HISTORIC AND DESIGN REVIEW COMMISSION

HDRC CASE NO: 2016-108

ADDRESS: 1024 S ALAMO ST

TYPE OF WORK: Additions and site modifications

A-2.00

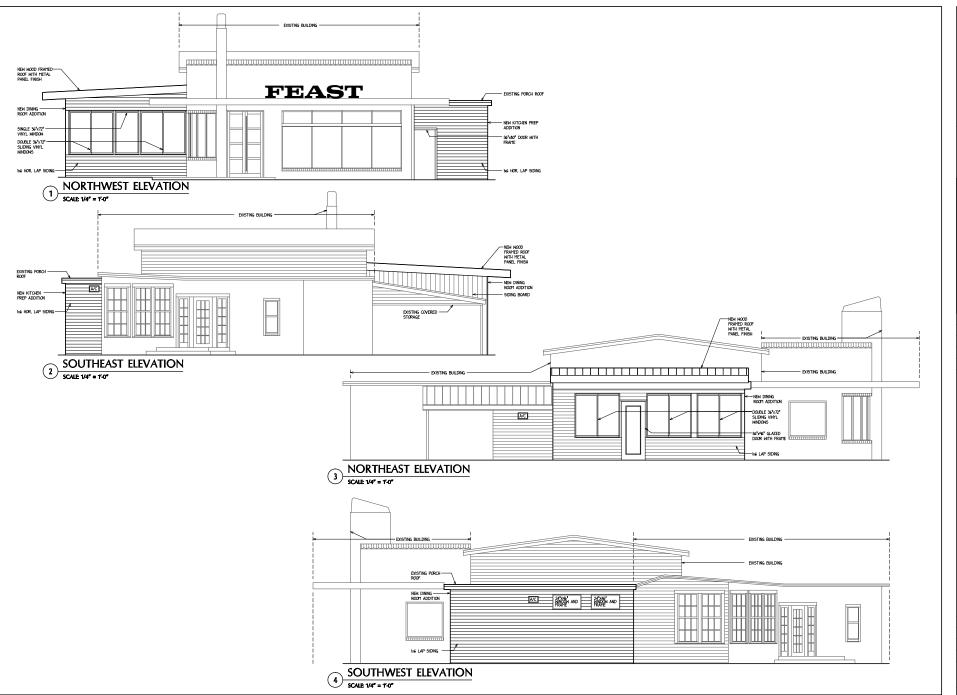
- e. The applicant has proposed to modify the existing landscaping and hardscaping in order to accommodate additional outdoor seating as well as construct a steel structure run the length of the brick paved area fronting S Alamo to be eight feet in height and eighty feet in length. Staff finds the proposed modifications appropriate, however, staff finds the addition of plant materials would be appropriate.

- i. That the applicant install aluminum or metal windows into the side addition to match those of the primary addition constructed circa 1950.
- ii. That the applicant install additional landscaping plant materials throughout the site. These plants should be native to South Texas.

A-1.00

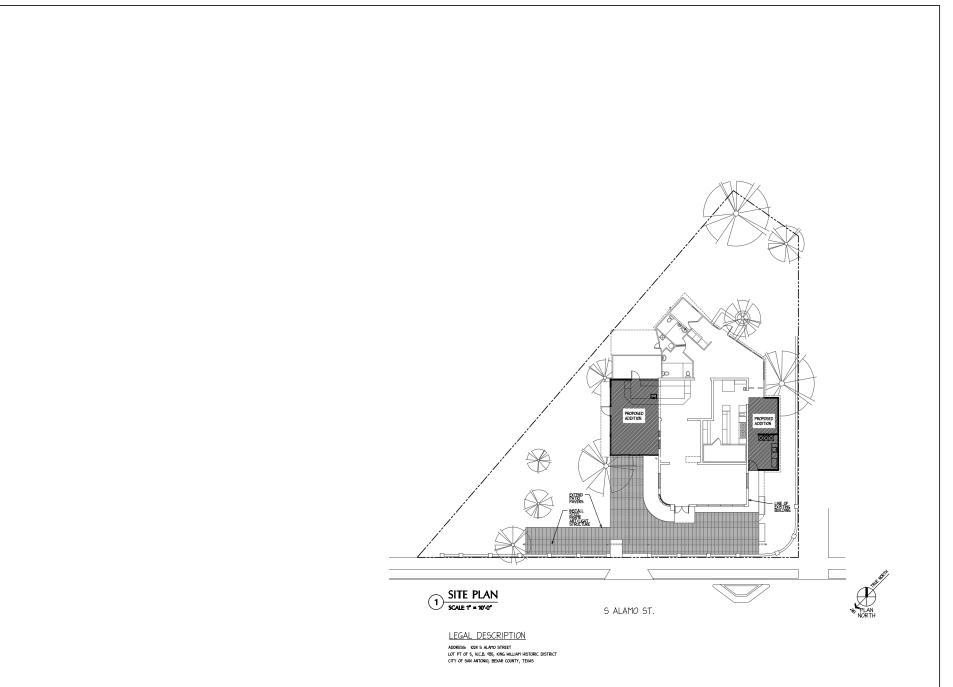
- c. The applicant has proposed materials that are to include horizontal lap siding, vinyl windows, a standing seam metal roof and doors featuring a composite material. The applicant's proposed materials of lap siding and a standing seam metal roof are appropriate, however, staff finds that aluminum windows and doors or those constructed of a metal material would be more appropriate than the proposed vinyl windows and doors.

- d. Architecturally, the applicant has proposed for the addition as well as the side enclosure to feature architectural elements that are complimentary and subordinate those of the existing structures. These elements include like materials and similarly proportioned façade elements. This is consistent with the Guidelines.
